THE MEDICAL CENTER OF AURORA

21-047 TMCA SOUTH OR SURGERY WAITING

ISSUE DATE: 27 MAY 2022
PROJECT #: 21-047

City of Aurora Building Division
Reviewed for Code Compliance
Approved as Noted: jlocke
Date: Feb 06, 2023
2021 INTERNATIONAL CODES & 2020 NEC

2 LEVEL 01 ELECTRICAL LIGHTING RCP

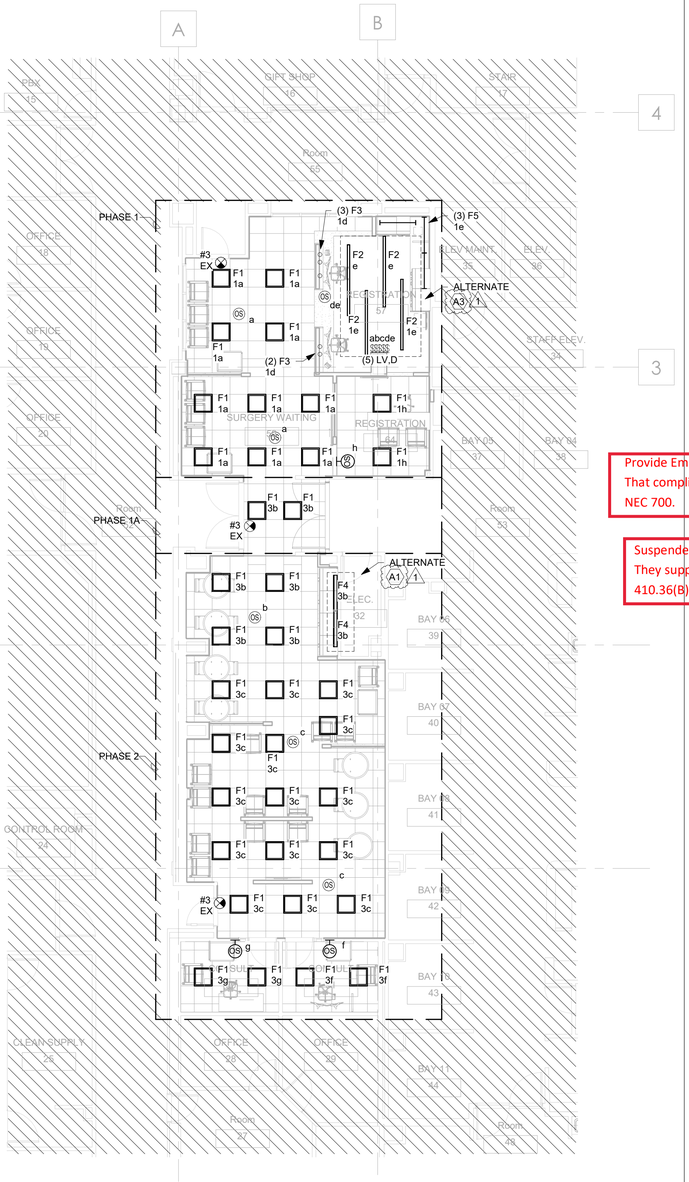
Provide Emergency Illumination Equipment That complies with 2020 NEC 700.12(F) or NEC 700.

1 LEVEL 01 ELECTRICAL POWER PLAN

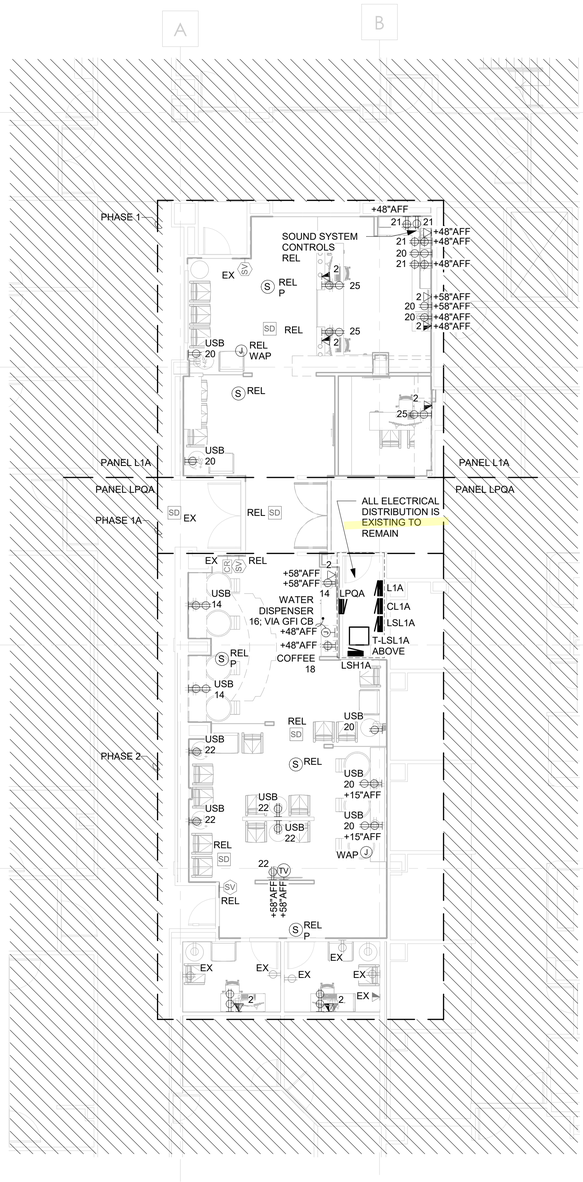
Tamper-resistant receptacles required in wainting rooms of medical facilities in accordance with 2020 NEC 406.12(5)
